# LB Lambeth Brixton Hill Controlled Parking Zone (CPZ) consultation

## QW Proposals & the proposed Brixton Hill CPZ

### 1. Tulse Hill junction southbound approach

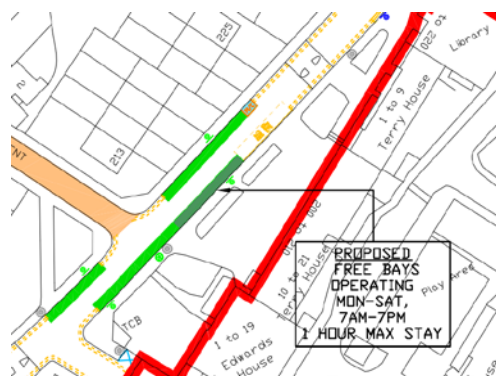
On site observations suggests that motorised vehicles often accelerate on the approach to the junction to avoid the existing long red signal phase. This creates a dangerous pinch point for cyclists when transitioning from primary position into the existing advisory filter lane. Sustrans recommends that the circled parking bays are removed from the proposals to mitigate against this conflict and allow cyclists a safe approach to the junction.
